#64-F-212C
W.P. #139-60
HWY #18
TURKEY CREEK

TURKEY CREEK BRIDGE
AT LA SALLE

W.P. 139-60,
Bridge Site 6-59,
Turkey Creek Bridge,
Hwy. 18 - Dist. 1.

FOUNDATION INVESTIGATION REPORT BY:
Geocon, Limited, Consulting Engineers.
Proposed Turkey Creek Bridge, Hwy. 18,
La Salle, Ontario, District No. 1.
W.P. 139-60.

BORE HOLE LOCATIONS & SOIL STRATA

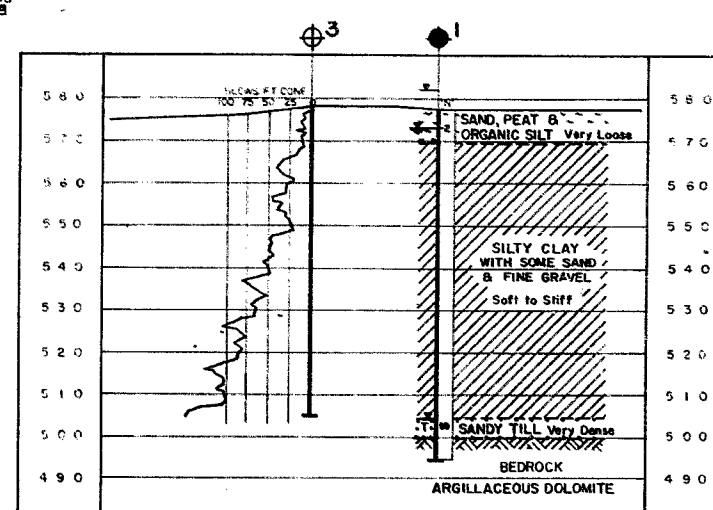
Your attention is drawn to the fact that on the crenaflex copy of the Drawing T-7569-1, the initially planned grade elevation of 535.7 is shown. The Consultant has, in his report, recommended that this elevation be lowered by 2.5 feet and if this elevation is finally adopted, the necessary corrections on the drawing should also be made.

The attached cronaflex copy of Drawing T-7569-1 shows the proposed grade at the abutments to be at elevation 585.7 as initially planned. It is our recommendation that this should be reduced by 2.5 feet as discussed in the report and that the Drawing should be corrected after final approval by the Department of Highways, Ontario.

PRELIMINARY PLAN

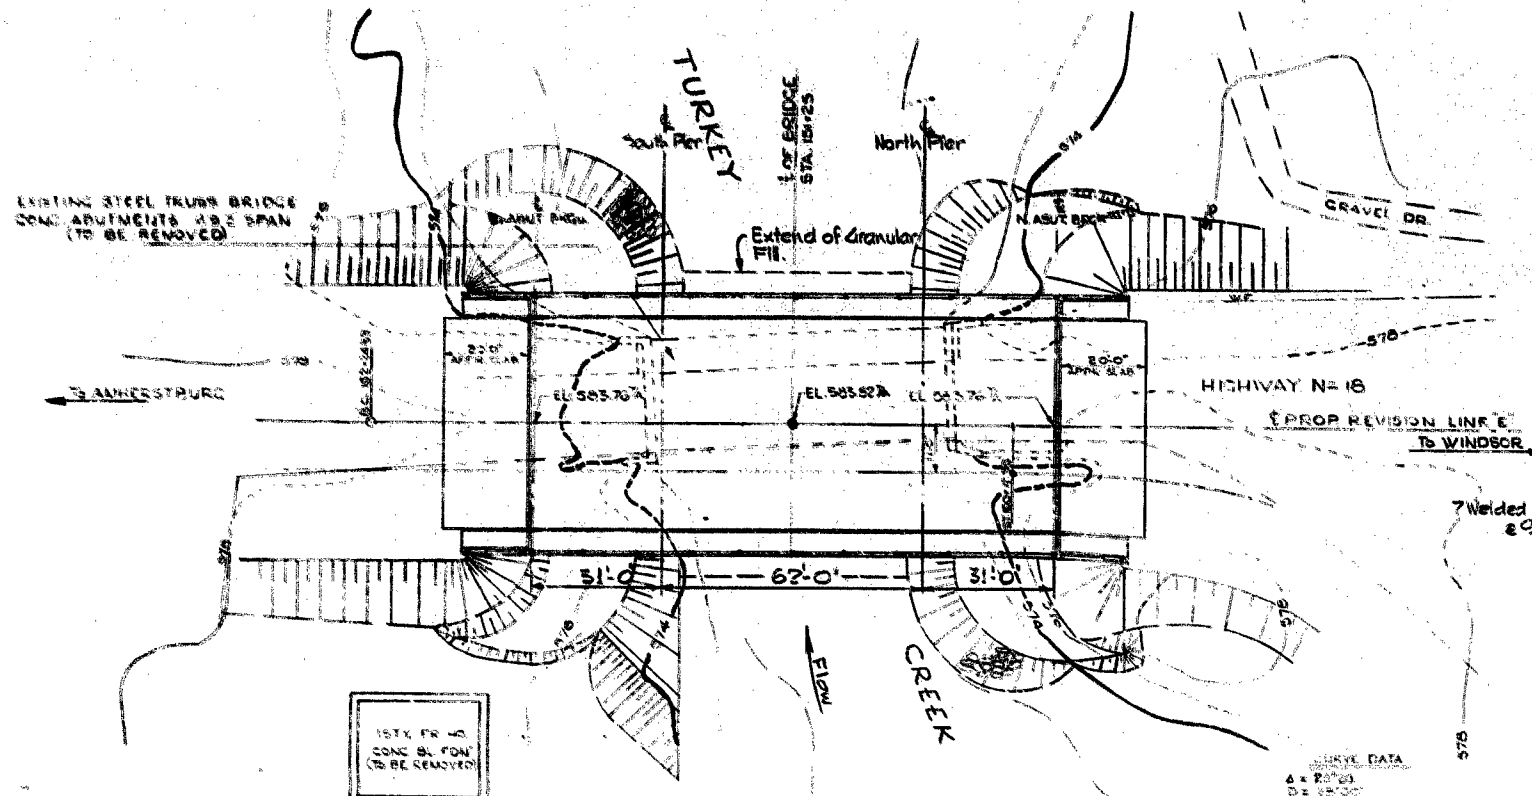
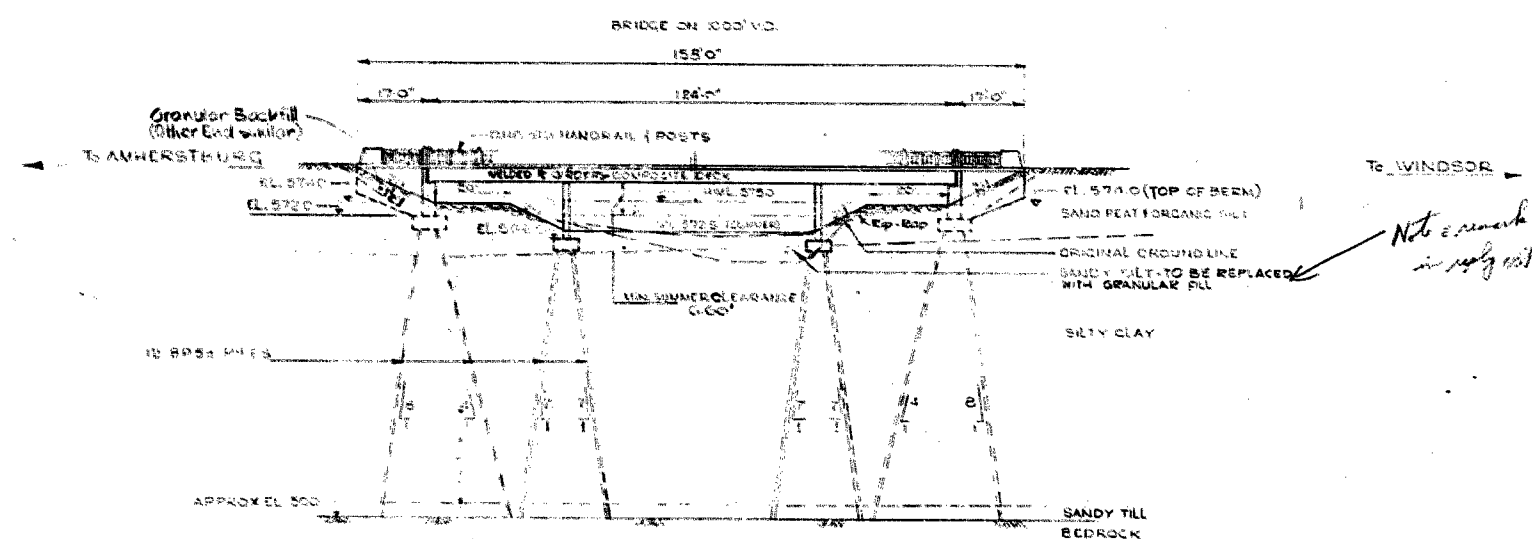
We have reviewed the Preliminary Plan D-5318-P2 for the above-mentioned structure and herewith, submit our comments for your consideration:

In the report dealing with the soil conditions, the Consultant, Geocon, Ltd., has recommended that the layer of organic silt, sand and peat be excavated and replaced with granular material. It was also suggested that the extent of this layer be checked with additional hand or power auger holes so that the limits of the material removal and replacement could be more precisely determined. As far as we are aware of, this has not been done.

It is therefore our recommendation that this be done as soon as possible. The fact that the exact location and bridge length are known, will pinpoint the area to be investigated quite precisely. We feel that this work could be best carried out by the Regional forces.

Once this information becomes available, an accurate plan can be prepared showing the boundaries and details of the excavation.

THIS DRAWING TO BE INTERPRETED IN CONJUNCTION
WITH DRAWING D-5318-P2

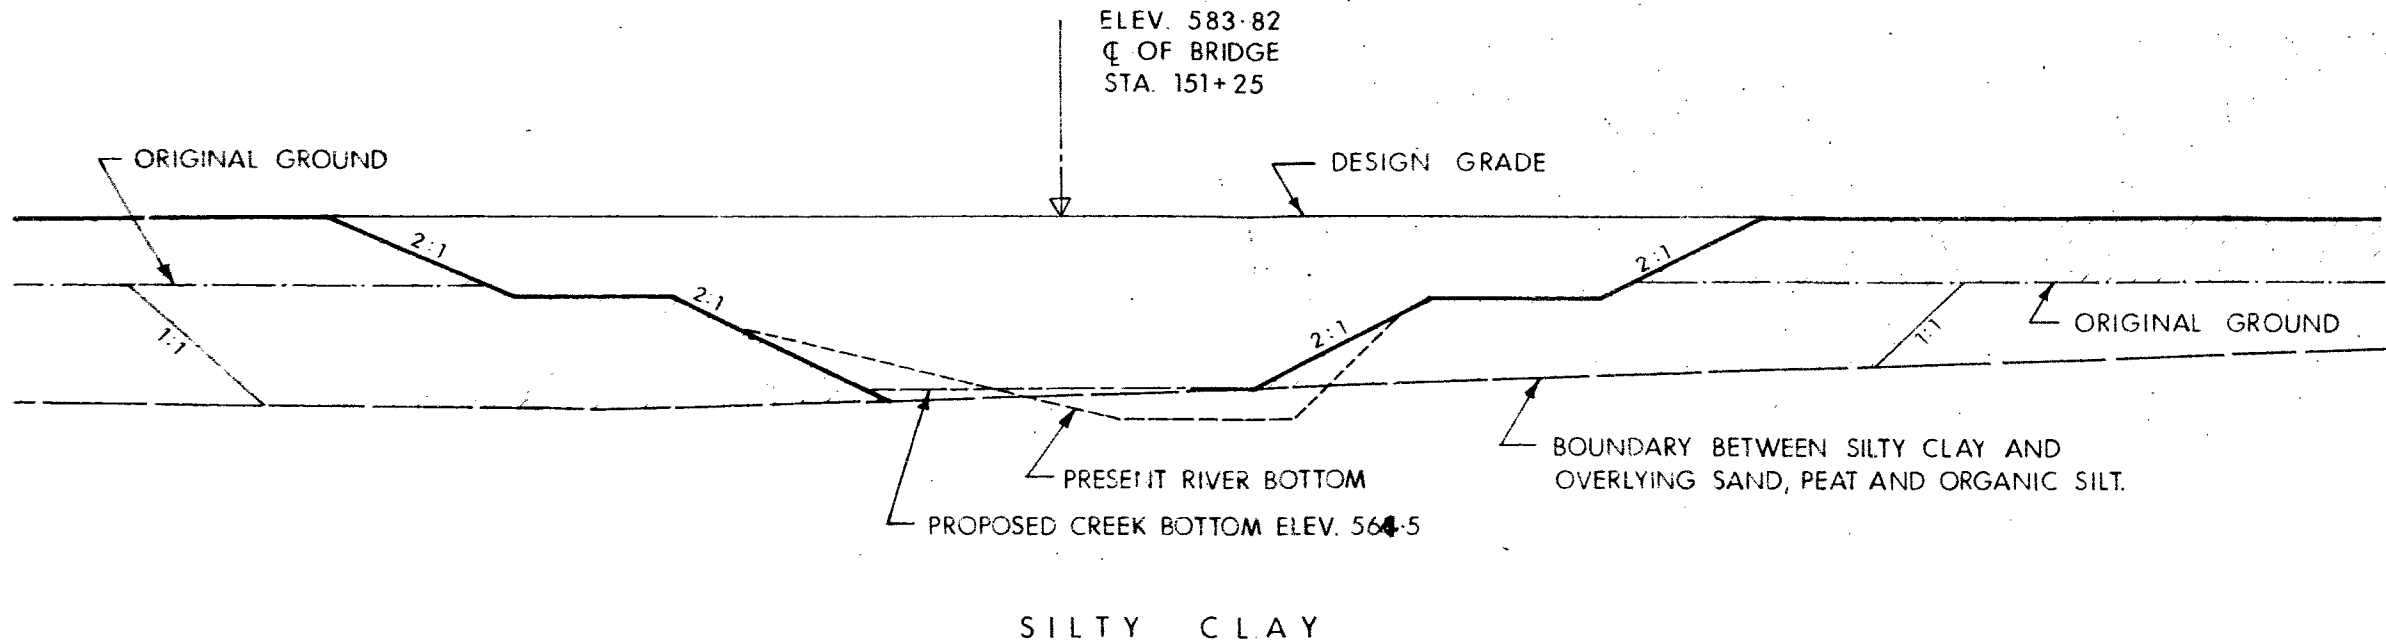
Attached, please find the sketch showing in cross section, the measures that we would suggest be carried out in order to make the proposed bridge stable and safe.

The shaded area on the drawing represents placed fill material. The placement of the part of this material below the present ground line will require excavating and removing the original material. In plan, this excavation should extend under the entire area of the berms and under a small part of the approach embankment. We are presently not aware whether the road design calls for the removal of the peaty material under the rest of the approach embankments.

It is recommended that only the part of the berms and embankments that will be under the water table during construction be built of granular material. The remaining portions can be built of any acceptable fill material using standard compaction equipment and techniques. It is also recommended that the slopes below H.W.L. be protected with rip-rap.

The suggested 1:1 slope at the far ends of the excavations may prove to be too steep and flatter slopes should then be made.

The boundary line between the silty clay and the overlying sand, peat and organic silt may differ from the one shown on the drawing. If and when such deviations are encountered, the depth of excavation should be modified accordingly.

We believe that the bottom of the creek bed can be at elev. 564.5 without endangering the proposed structure.

THIS DRAWING TO BE INTERPRETED IN CONJUNCTION
WITH DRAWING D-5318-P2

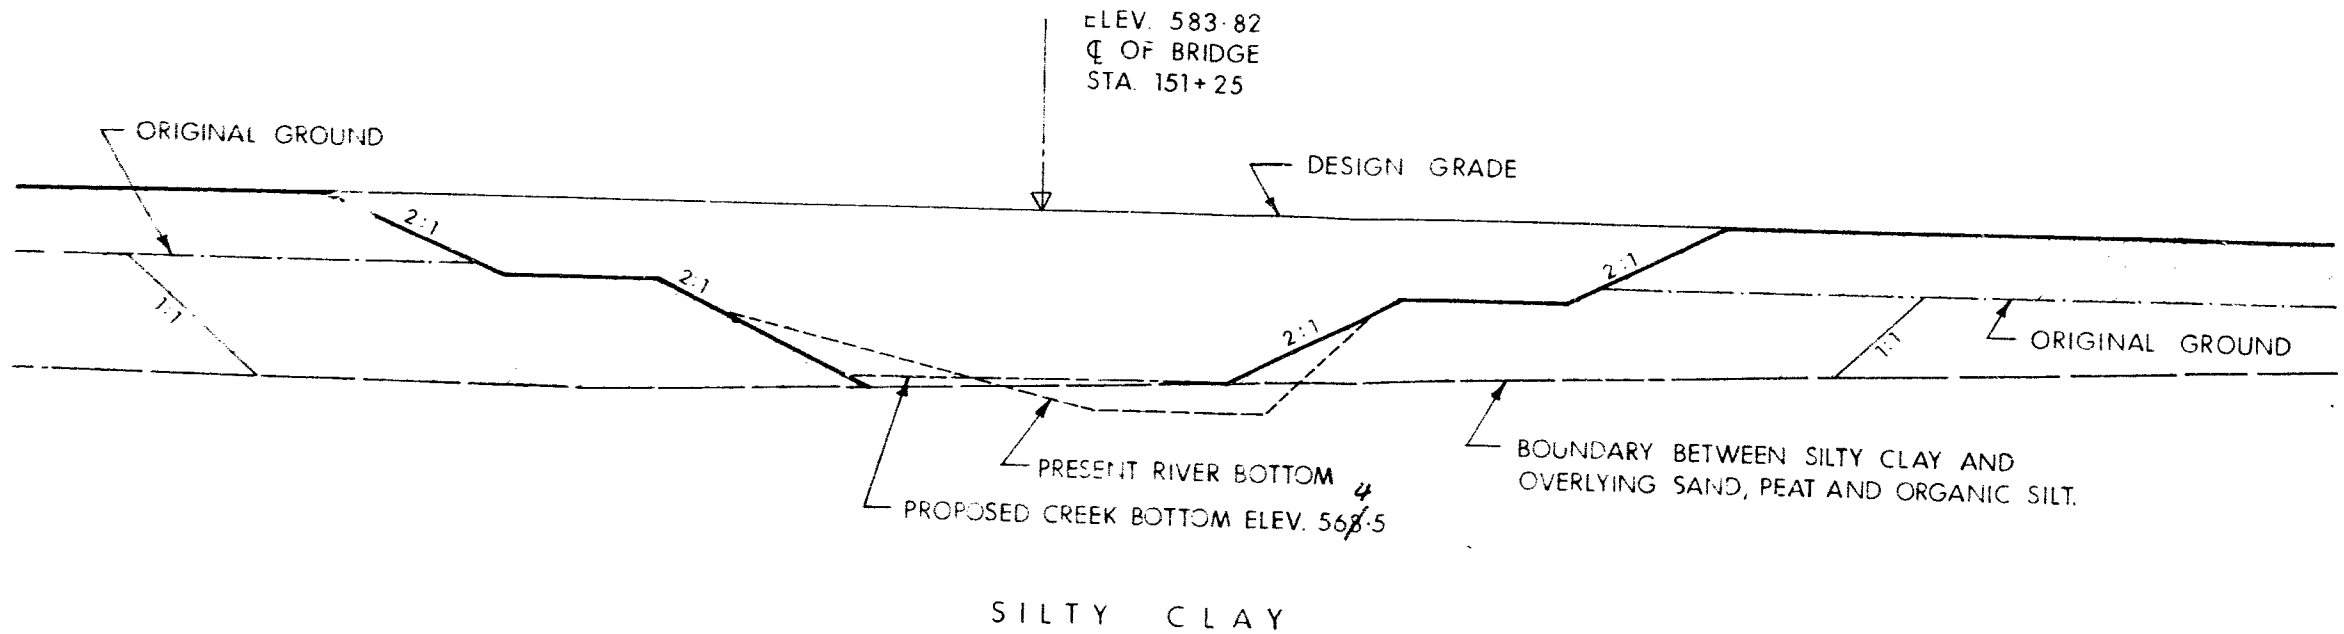
The shaded area on the drawing represents placed fill material. The placement of the part of this material below the present ground line will require excavating and removing the original material. In plan, this excavation should extend under the entire area of the berms and under a small part of the approach embankment. We are presently not aware whether the road design calls for the removal of the peaty material under the rest of the approach embankments.

The boundary line between the silty clay and the overlying sand, peat and organic silt may differ from the one shown on the drawing. If and when such deviations are encountered, the depth of excavation should be modified accordingly.

We believe that the bottom of the creek bed can be at elev. 567.5 without endangering the proposed structure.
